July 22, 2016

ADDENDUM NO. 04

RANKIN TRAILS AMPHITHEATER AND BASEBALL PARK

Rankin County, Mississippi

Plan and Profile
South West Ballfield
Entrance

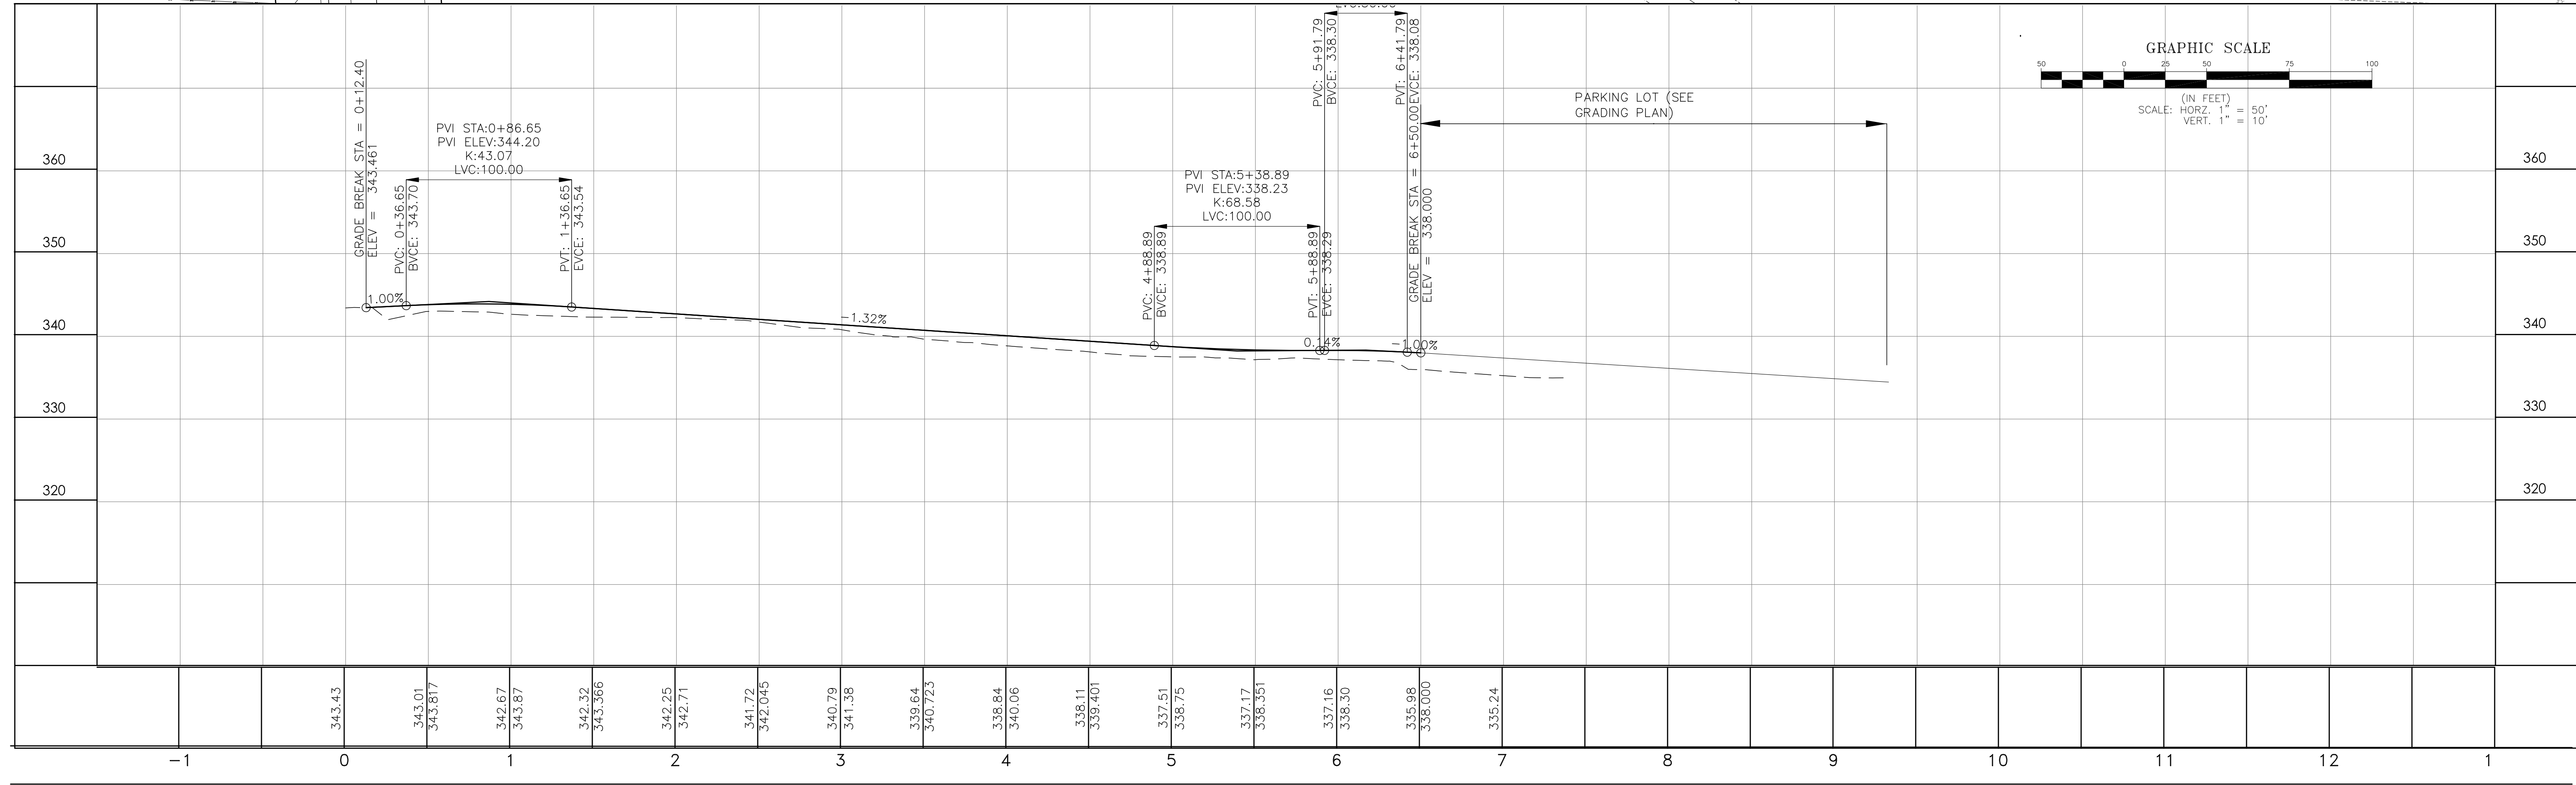
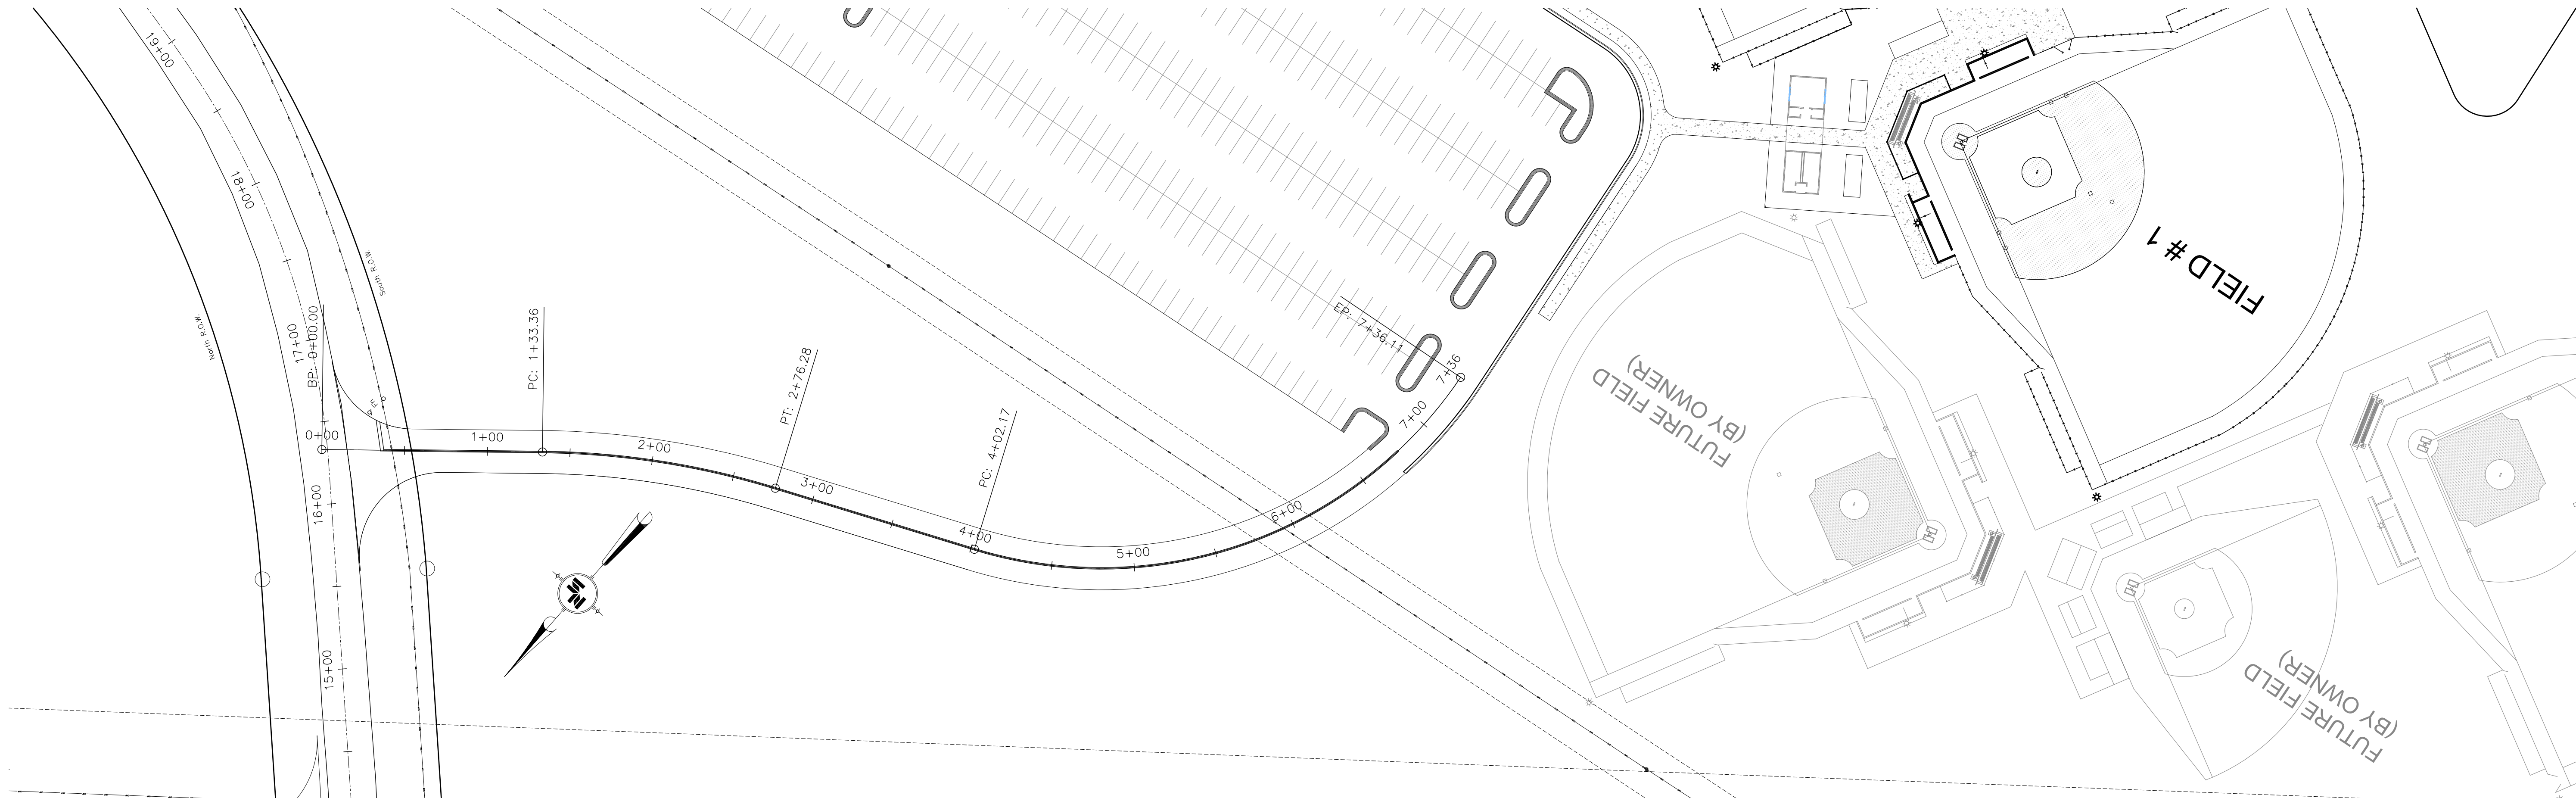
- ITEM NO. 24 SHEET C3.3**
REVISE per enclosed sheet C3.3. Updated profile line.
- ITEM NO. 25 SHEET C5.1-C5.2**
CLARIFICATION: Items in Erosion Control Plans were submitted with the SWPPP by the Owner. Contractor is responsible for maintaining these items and installing any items additional as necessary and shown for Erosion Control.

FIELD DETAIL

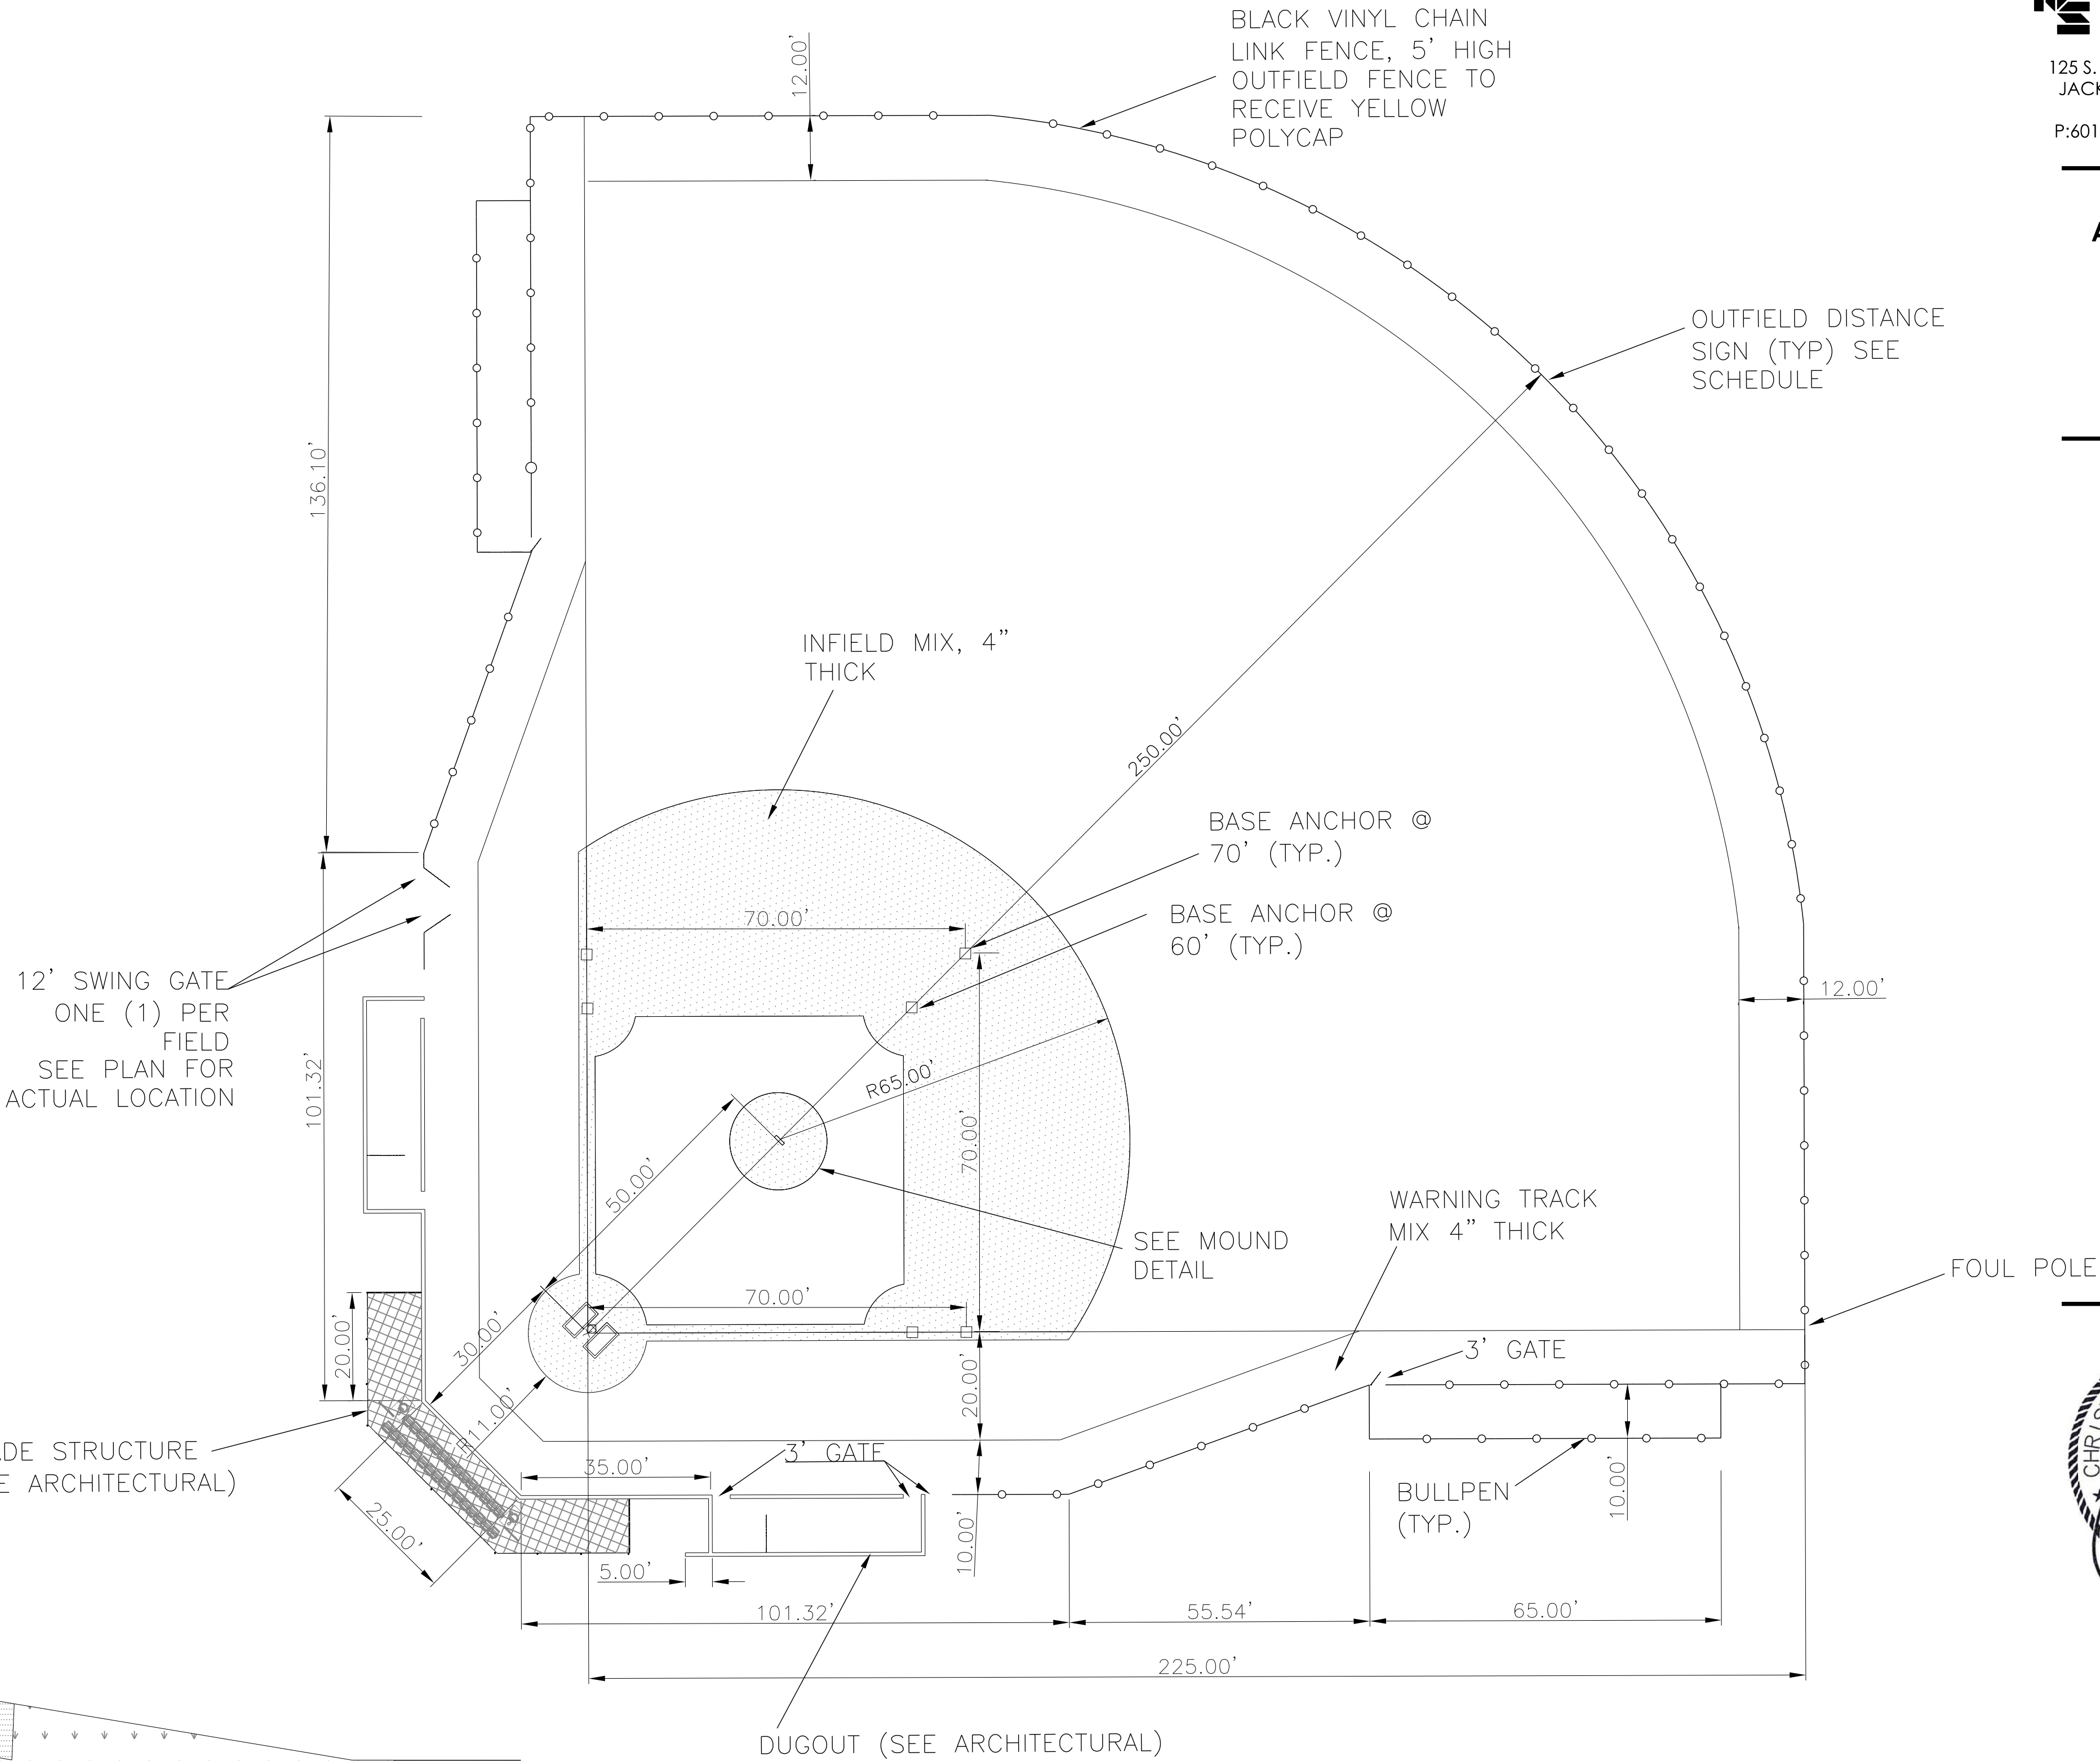
- ITEM NO. 26 SHEET C6.2**
REVISE per enclosed sheet C6.2. Added a note indicating a 1/3" +/- tolerance on baseball field laser grading.
- ITEM NO. 27 SHEET C6.4**
REVISE per enclosed sheet C6.4. Cleaned up dimensions on details.

- NOTES:
1. ALL GRASS AREAS WITHIN FIELD SHALL RECEIVE 6" SELECT TOPSOIL (SEE SPECIFICATIONS) AND BERMUDA GRASS SOD, TIFWAY 419.
 2. CONTRACTOR RESPONSIBLE FOR FINE GRADING ALL AREAS. ALL BSEBALL FIELDS SHALL BE SHAPED USING LASER GUIDED EQUIPMENT, WITH A 1/3" TOLERANCE.
 3. CONTRACTOR SHALL SET BASE ANCHORS AT 60' & 70'. BASES AND PLUGS TO BE PROVIDED.
